GROUP <b>BOD</b>	MODEL <b>2015-2017MY Sedona (YP)</b>
	NUMBER <b>158</b>	DATE <b>December 2016</b>
<b>TECHNICAL SERVICE BULLETIN</b>		
<b>SUBJECT:</b>	<b>2<sup>ND</sup> ROW STAND-UP SEAT LEVER MOUNTING BOLT REPLACEMENT (SA258)</b>

**SUBJECT: 2<sup>ND</sup> ROW STAND-UP SEAT LEVER MOUNTING BOLT REPLACEMENT**

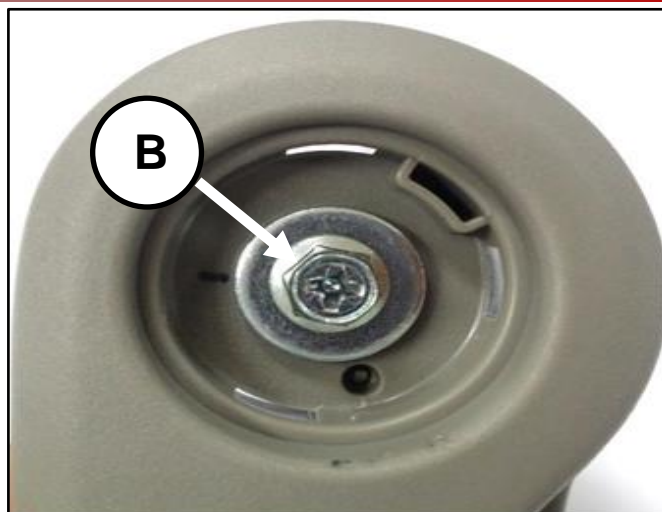
2. After confirmation, follow the service procedure below to replace the mounting bolt for the seat lever with an improved one.
3. Remove the seat lever cover (A) with an appropriate plastic trim removal tool.

4. Remove the seat lever mounting bolt (B) and discard.

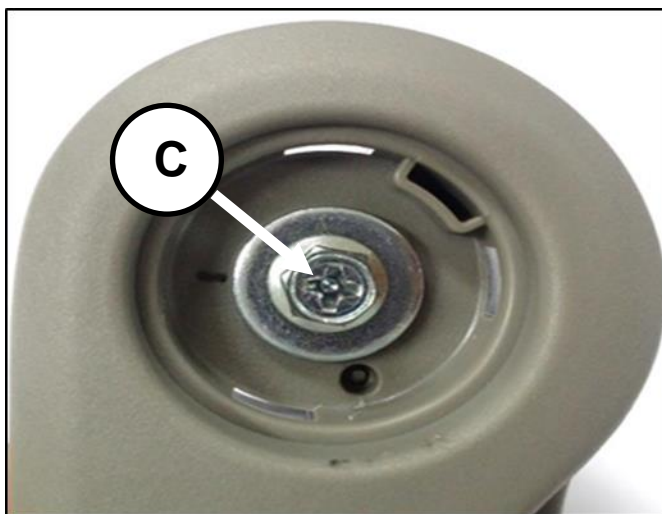
5. Install the new improved seat lever mounting bolt (C).

**Tightening Torque:**

3.6 ~ 4.3 lb-ft

(4.9 ~ 5.9 N.m 0.5 ~ 0.6 kgf.m,)

To ensure proper tightening, be sure to use a socket wrench when applying torque to the mounting bolt. **DO NOT** use a screwdriver.
